Re: Indian Point Unit No. 2  
Docket No. 50-247  
RT<sub>PTS</sub> Rule - 10 CFR 50.61

Supplemental Information

Indian Point Unit 2

RT<sub>PTS</sub> Submittal

FIGURE 1

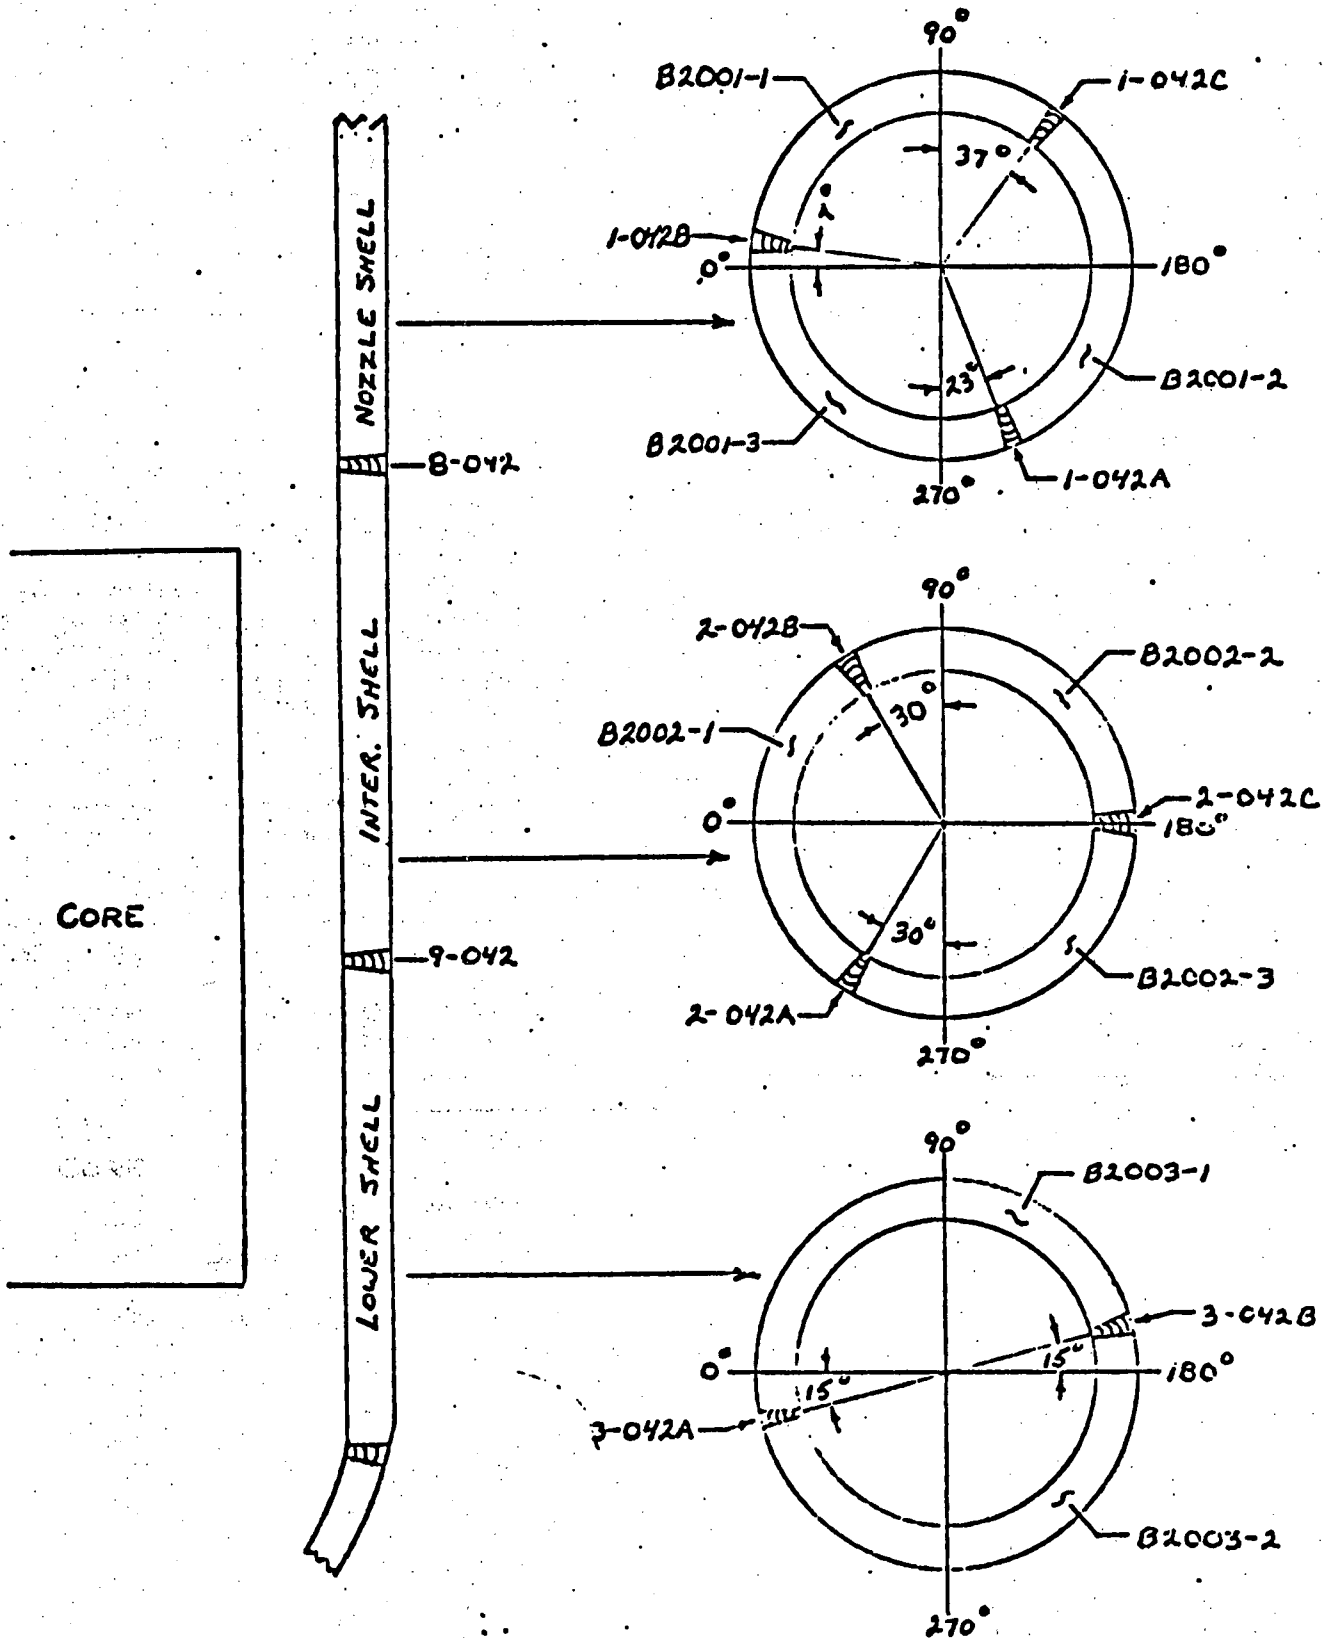
Our letter to you dated January 22, 1986 provided the current and projected values of RT<sub>PTS</sub>, the reference temperature (for nil ductility transition) for pressurized thermal shock evaluation, for Indian Point Unit 2 reactor vessel beltline material. Enclosed is additional information on that submittal as requested by your staff. A figure entitled "Identification and Location of Beltline Region Material for the Indian Point Unit 2 Reactor Vessel" is also provided to supplement our previous submittal. This new figure replaces "figure 1" as enclosed with our January 22, 1986 letter.

Revised Figure 1
